**Re: CambridgeSide 2.0 Project – Canal Park Design Review**

**CambridgeSide 2.0**  
**Canal Park Design**  
**Review Supplement**

# Canal Park Design Review Summary of Response to Comments

## MALL EDGE / THORNDIKE: PLANTING

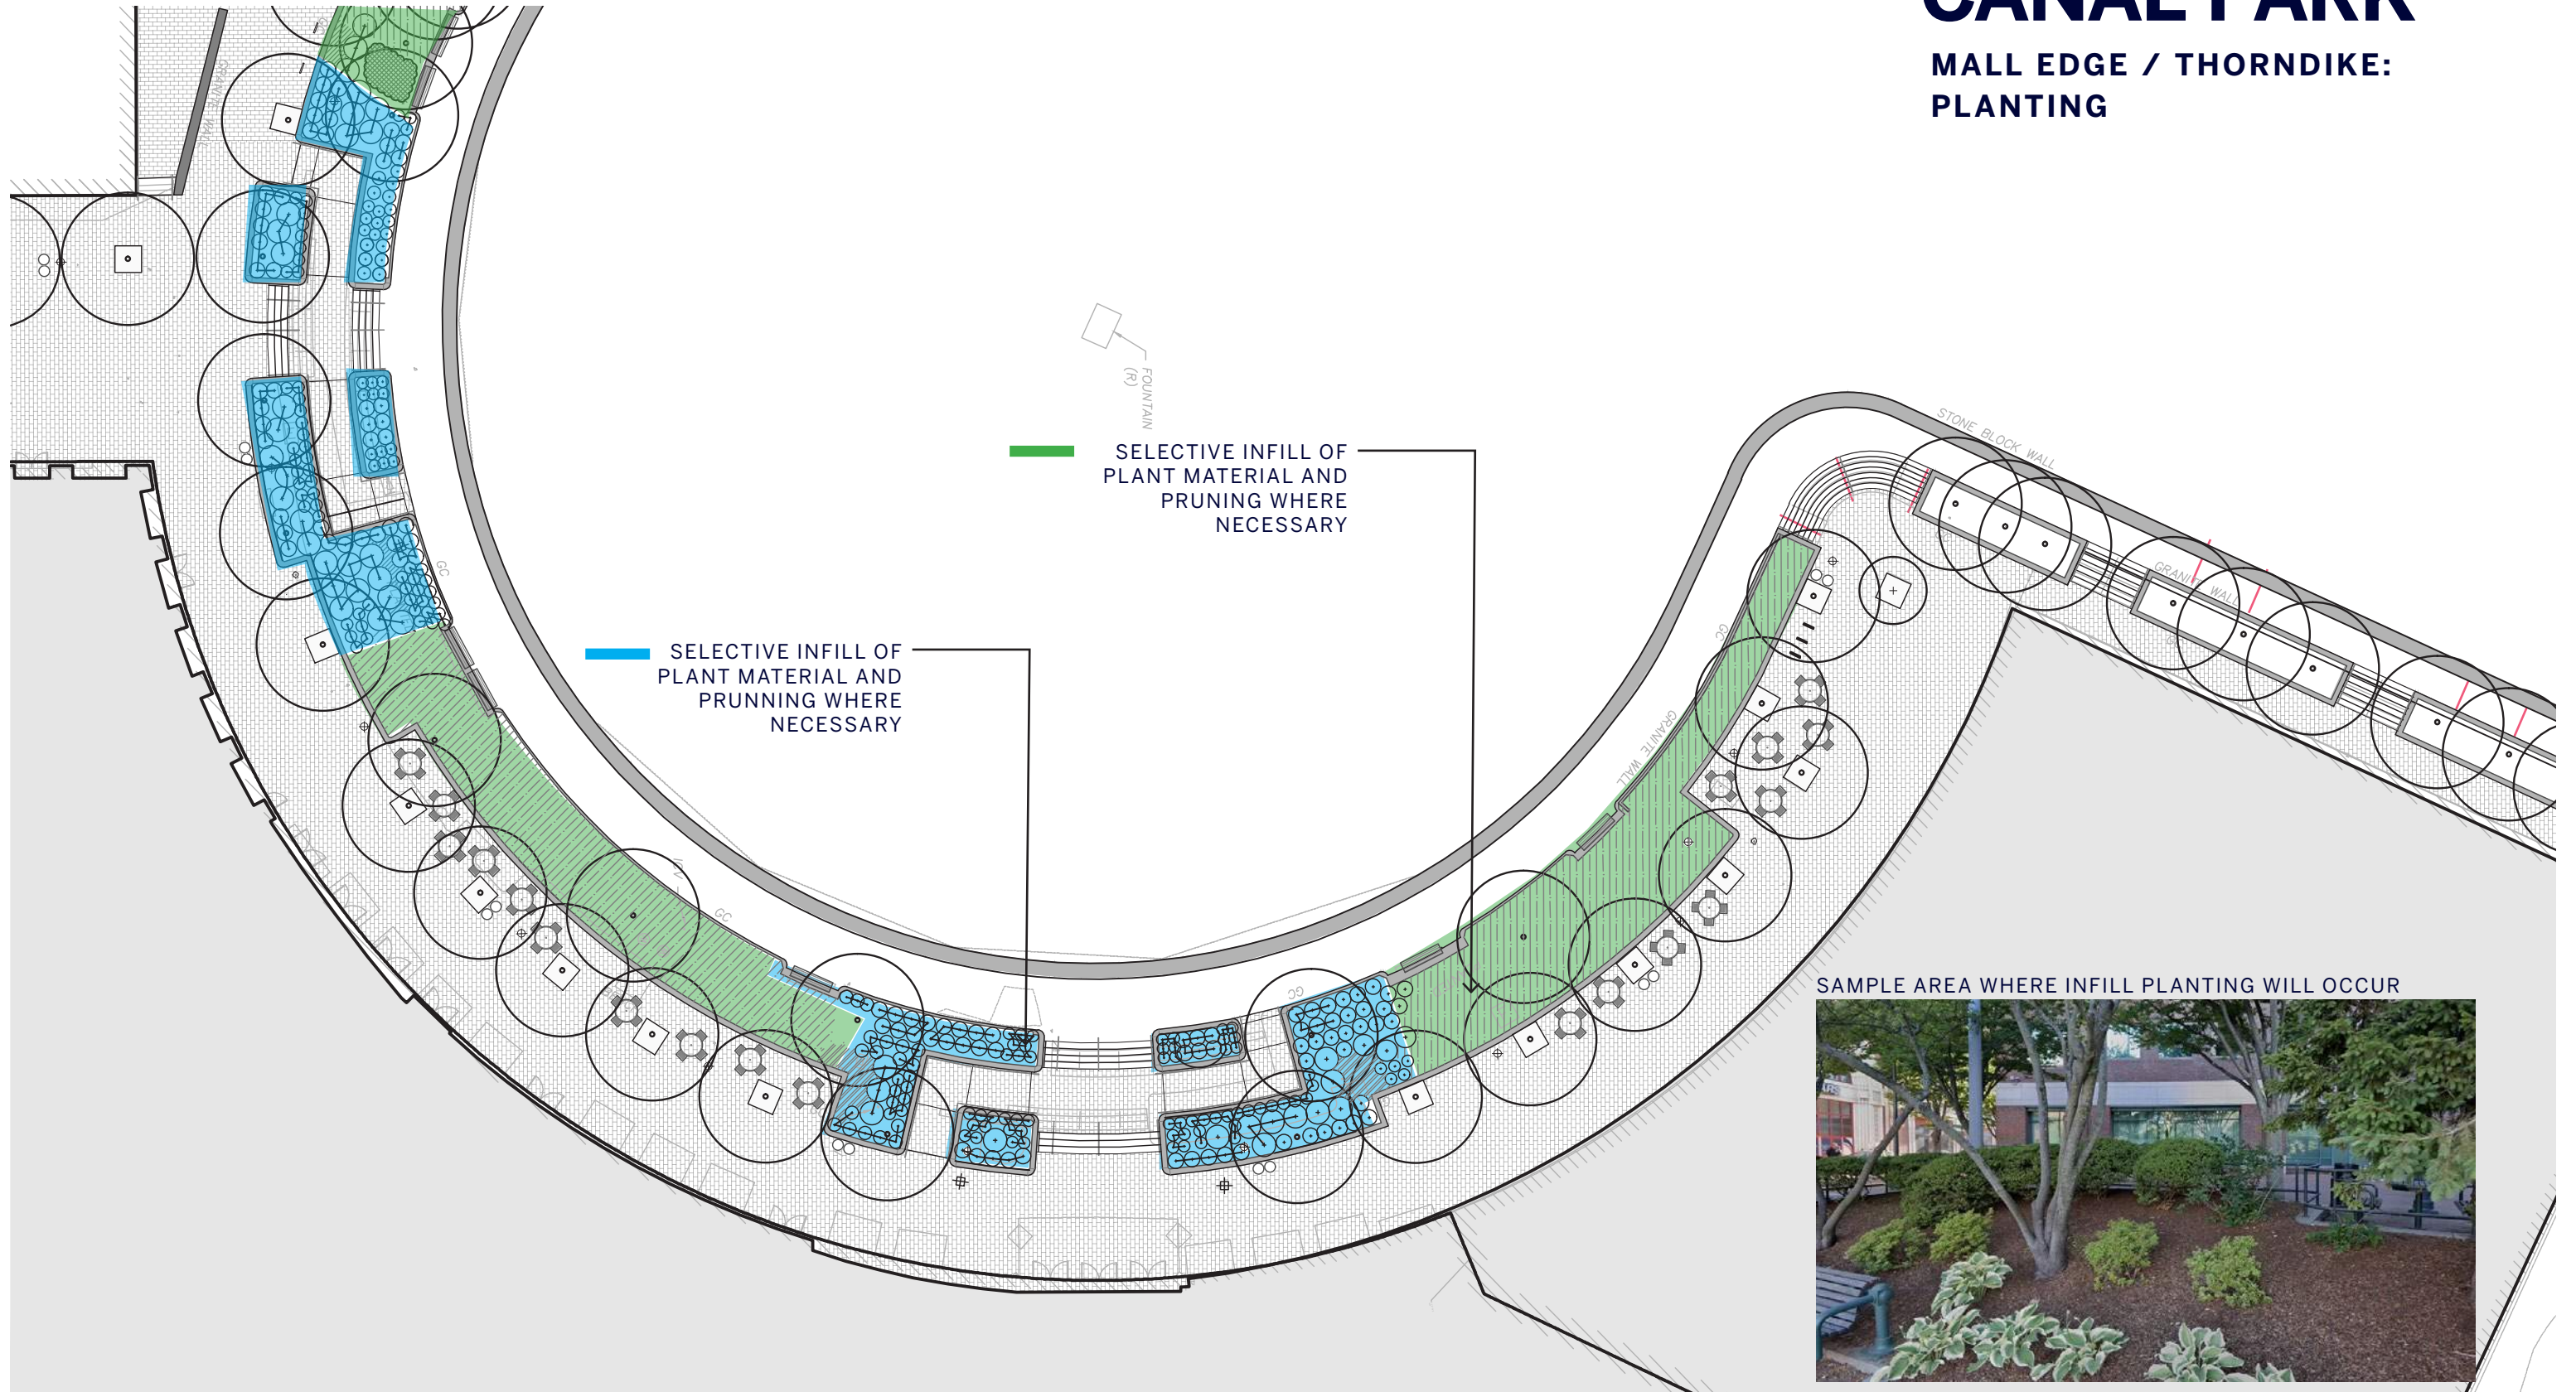
- a. **EXHIBIT 11B/C, Pages 15/16:** In response to a request to clarify existing and proposed plantings, we have prepared a diagram highlighting that new plantings will be incorporated primarily at the reconstructed stairs/ramps at the mall entry and Thorndike Way.
- b. **EXHIBIT 15A, Page 21:** In response to concerns about preserving the existing tree in the Great Lawn as part of regrading the area, we have provided a more detailed illustration of the grading intent noting existing and proposed contouring. The existing evergreen tree will be preserved. Additionally, we have noted the extent of railing removal and preservation at the north edge of the Great Lawn.

## GREAT LAWN:

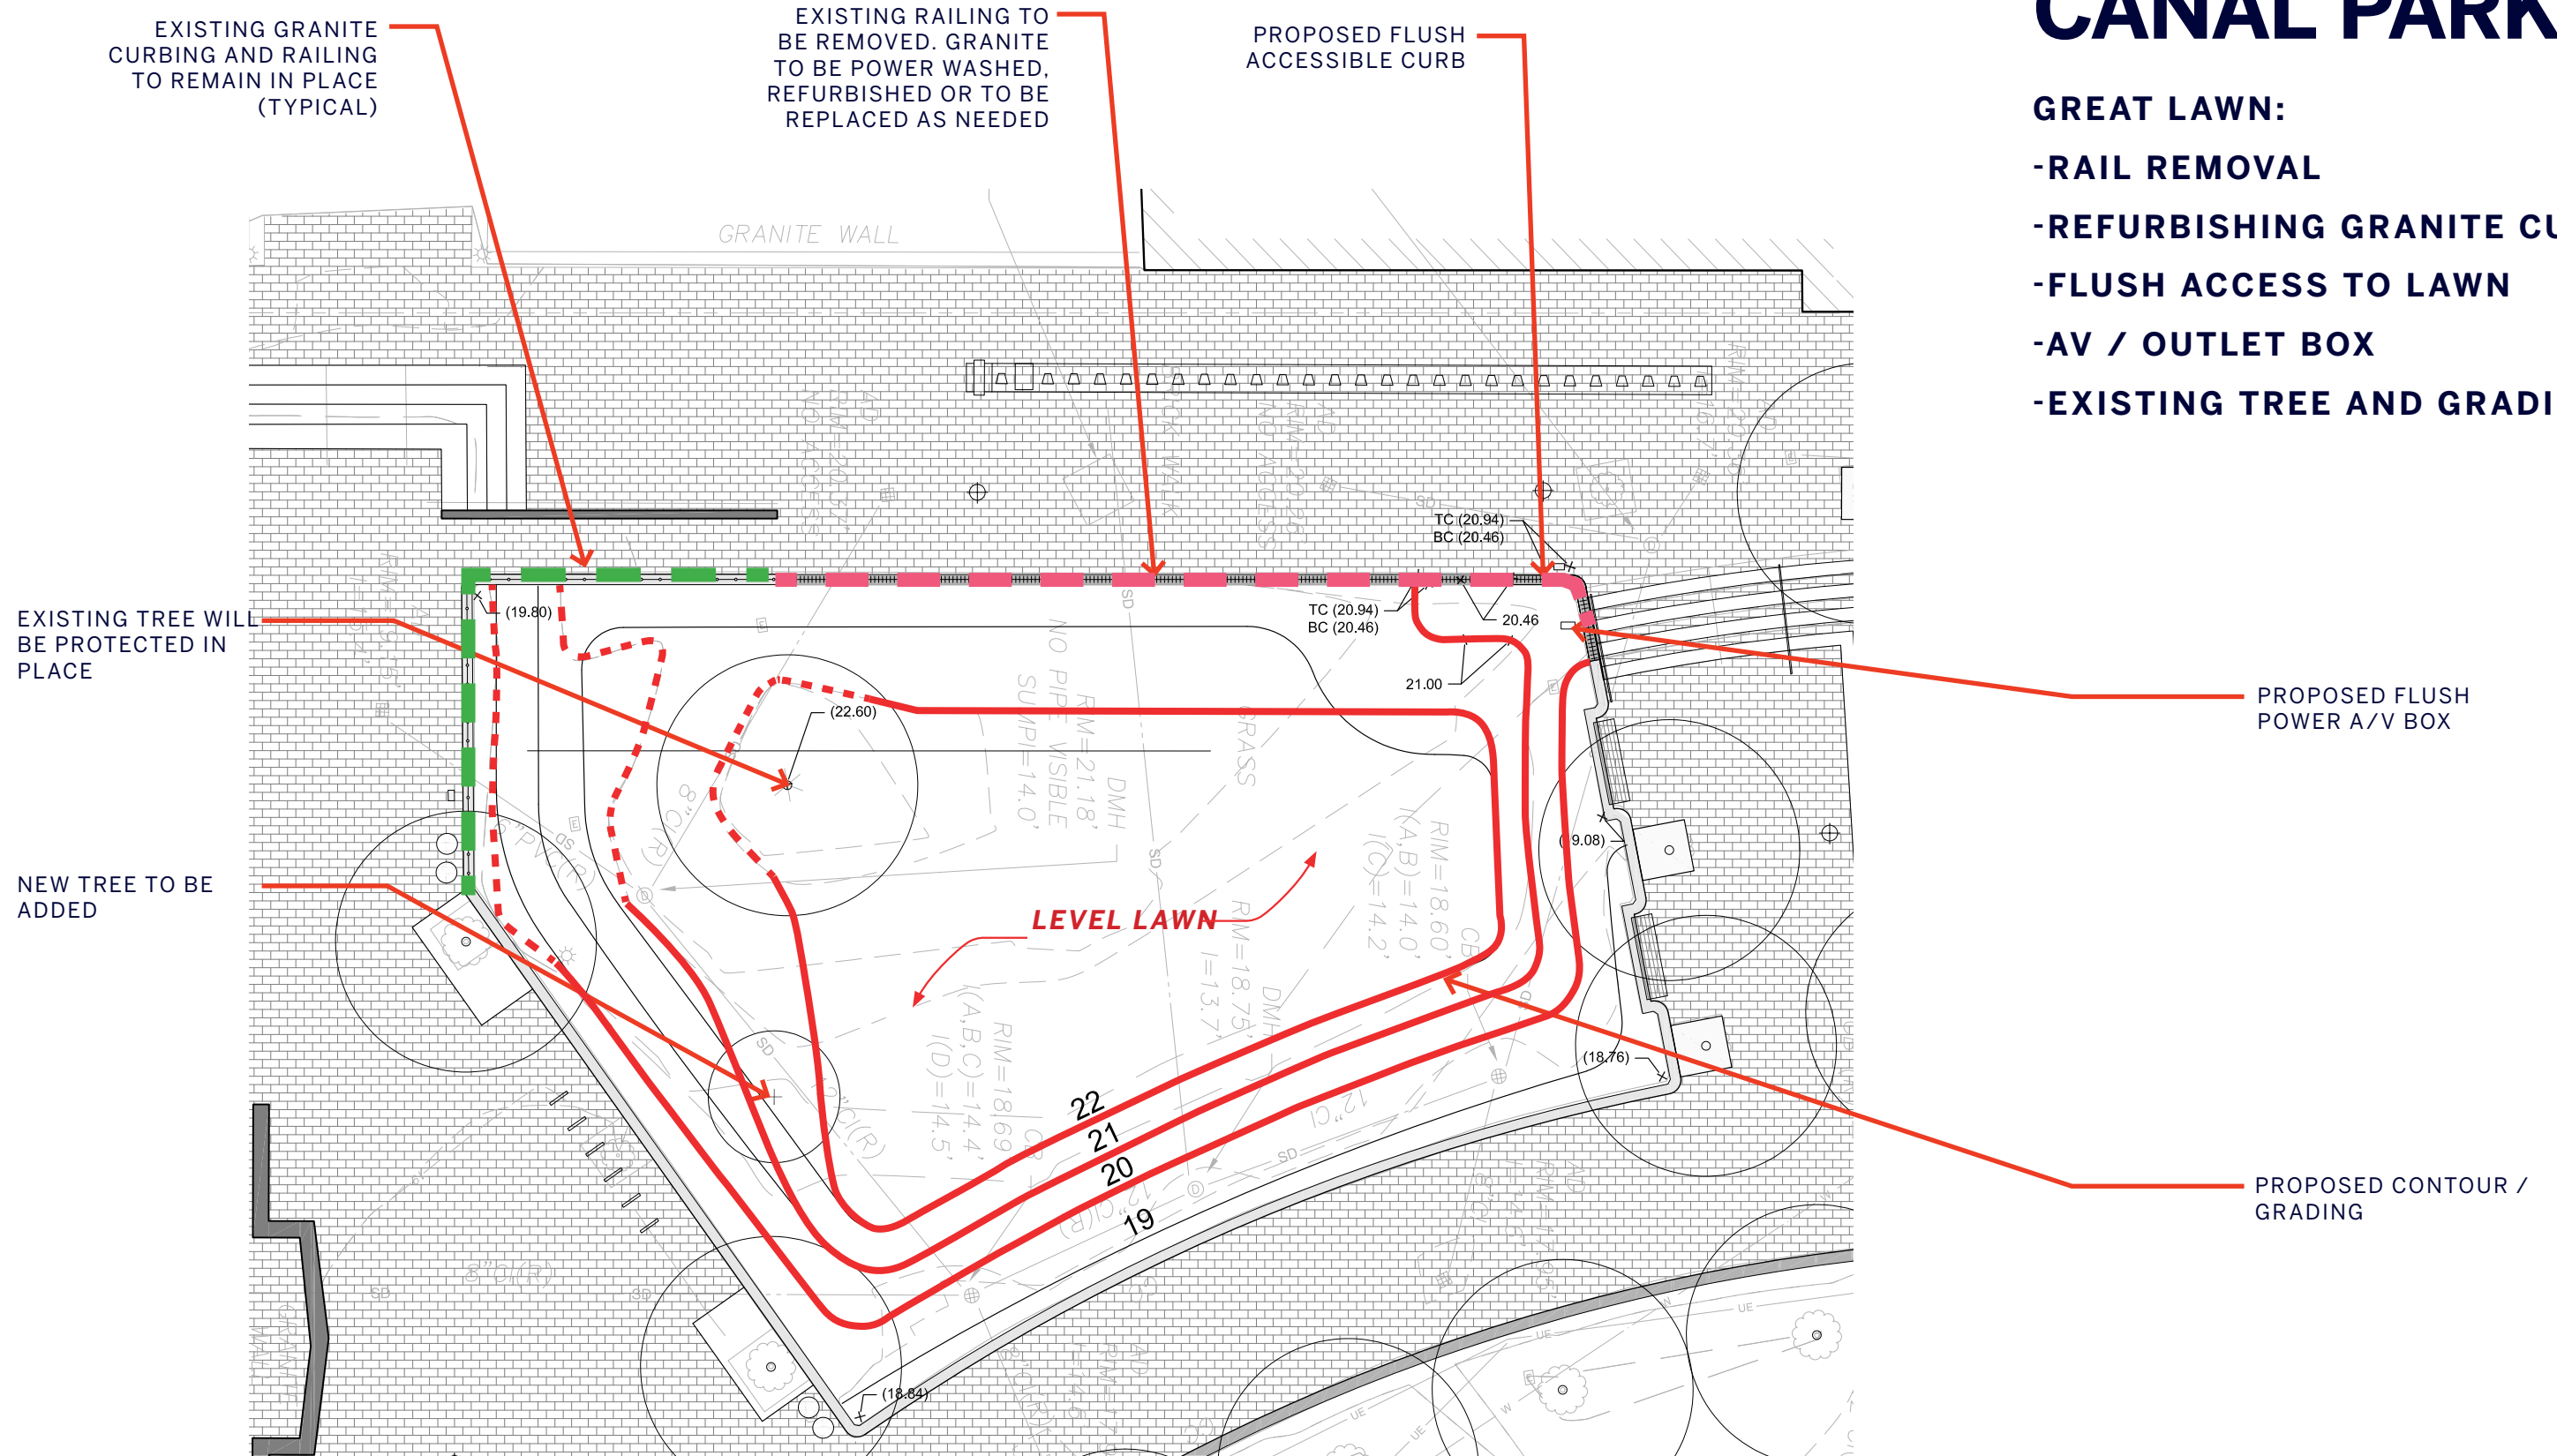
- a. **EXHIBIT 15A, Page 21:** In response to a request to identify the capability to support performance areas, we have noted the incorporation at the Great Lawn of an electrical service box for A/V use during scheduled events.

- RAIL REMOVAL
- REFURBISHING GRANITE CURB
- FLUSH ACCESS TO LAWN
- AV / OUTLET BOX
- EXISTING TREE AND GRADING

Exhibit 15B

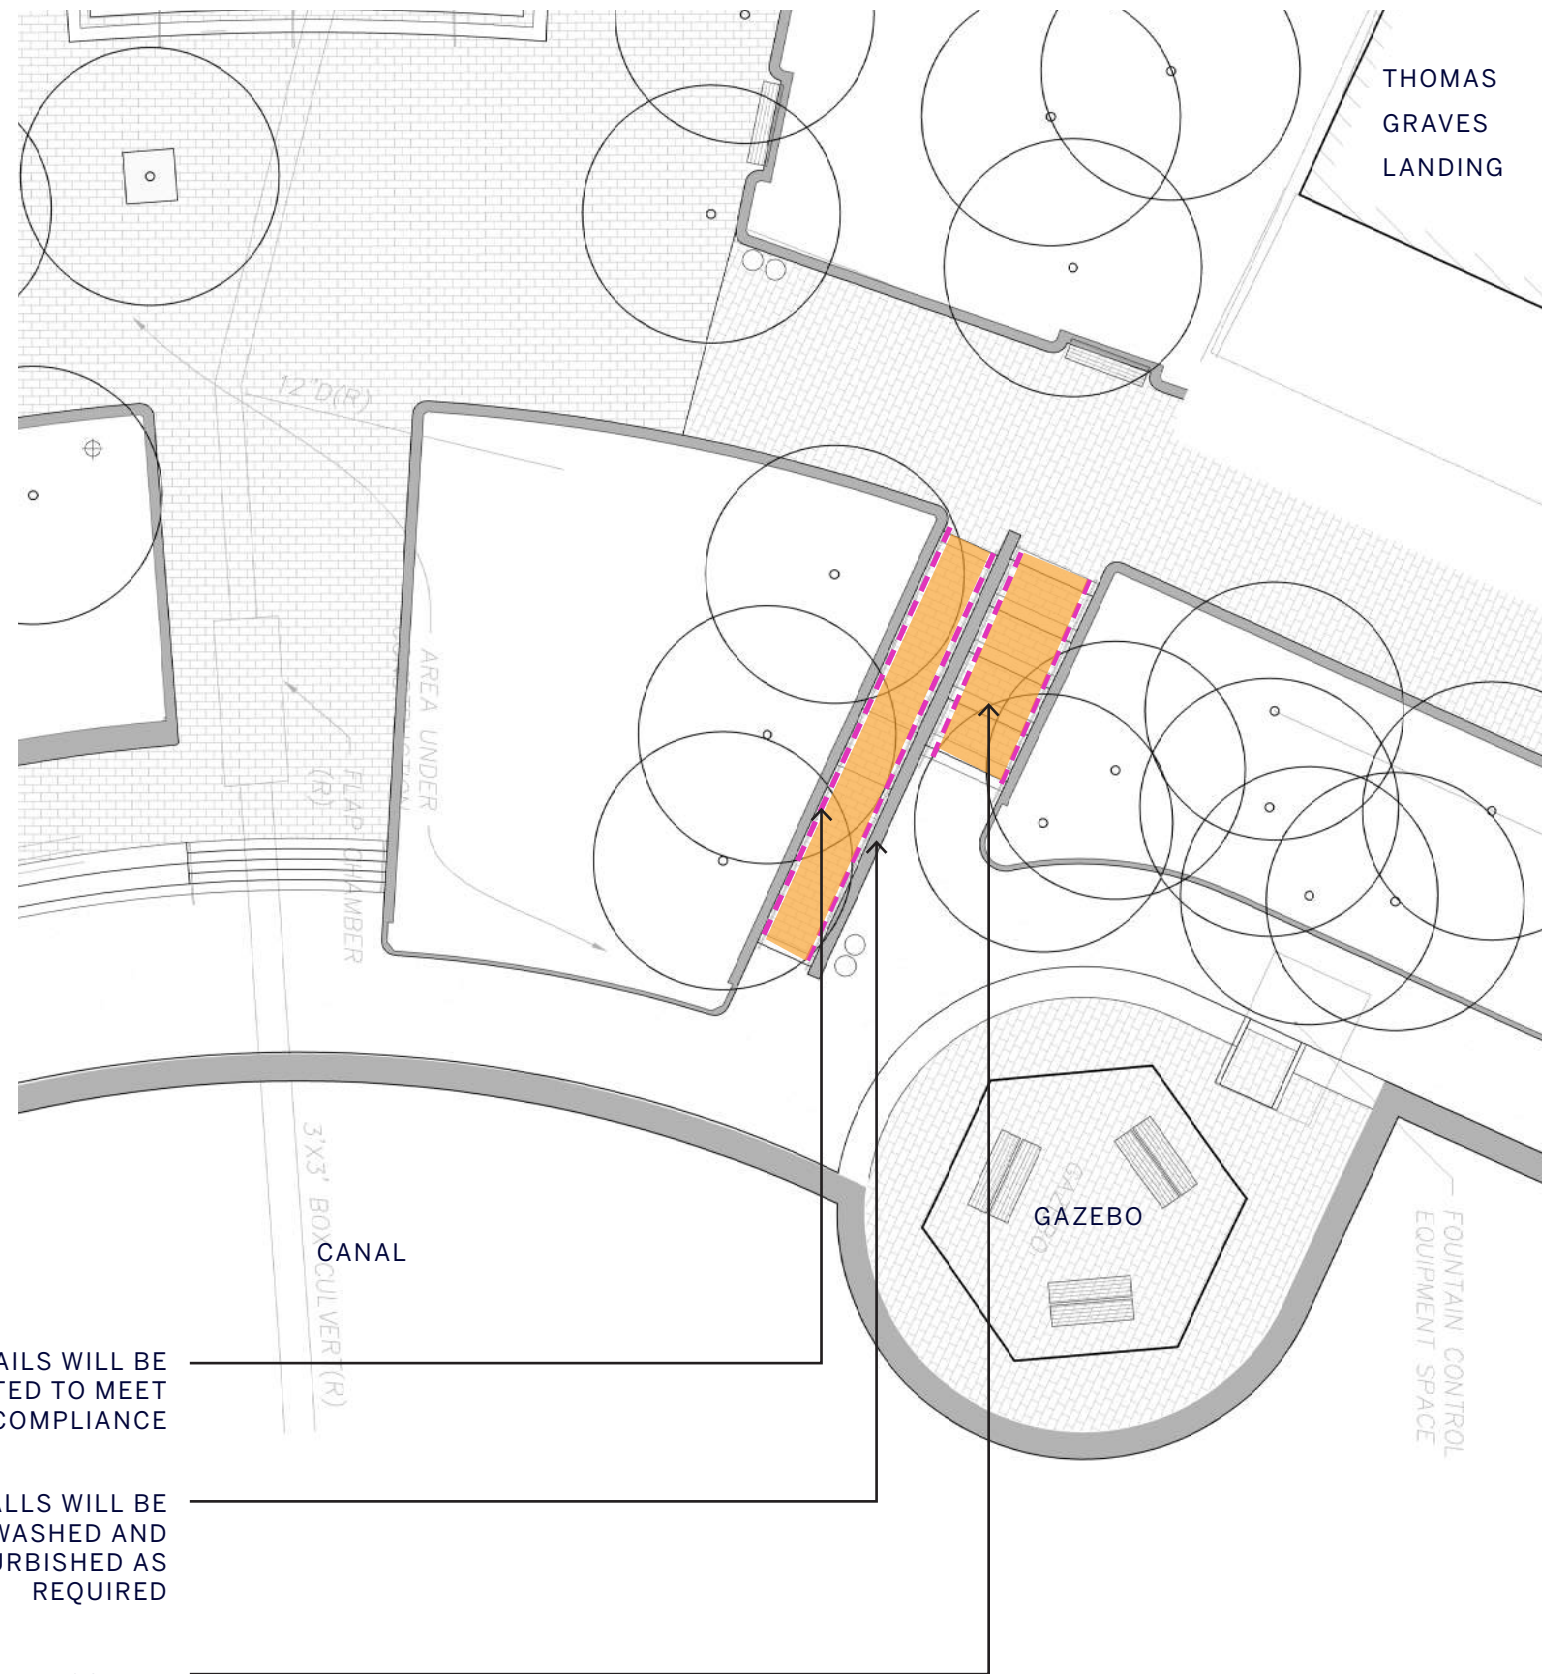
- a. **EXHIBIT 15B, Page 22:** In response to a request for clarity on the extent of modifications to the accessible ramp and stairs near the gazebo, we have updated this exhibit to identify specific improvements, which include resetting bricks as needed to meet ADA compliant slopes, modifying existing ramp and stair handrails for ADA compliance, and power washing granite curbing.

REFURBISH  
RAILS TO  
MEET CODE

UPDATE  
SLOPES TO  
MEET CODE

HANDRAILS WILL BE  
RETROFITTED TO MEET  
ADA COMPLIANCE

GRANITE WALLS WILL BE  
POWER WASHED AND  
REFURBISHED AS  
REQUIRED

BRICK LANDINGS AND  
BRICK RAMP WILL BE  
RESET TO MEET ADA  
COMPLIANT SLOPES

## THOMAS GRAVES LANDING: GUARDRAIL DESIGN

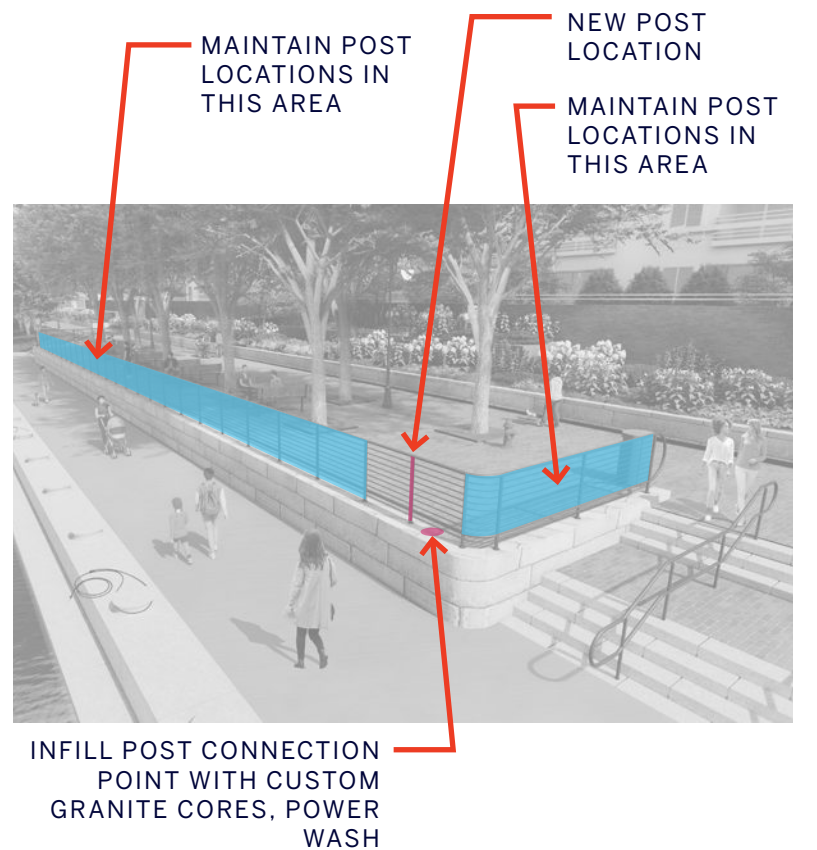
- a. **EXHIBIT 25A, Page 36:** In response to comments about the new guardrail matching the existing post spacing, we have updated the illustration to accurately represent the intention to reuse the existing post spacing as part of the update to achieve ADA code compliance. We confirmed that horizontal pickets are an acceptable solution by current code. The horizontal pickets are spaced to ensure openings of less than 4". The existing rail design will be replicated at a 42" height (from existing 36" height) as required by code.

PROPOSED RAIL:  
ROUNDED STEEL HORIZONTAL PICKETS  
PAINT TO MATCH EXISTING  
OVERALL HEIGHT INCREASED TO MEET  
GUARDRAIL CODE

REFURBISHED STAIR  
HANDRAIL. EXISTING RAIL  
TO BE MODIFIED TO MEET  
CODE COMPLIANCE.
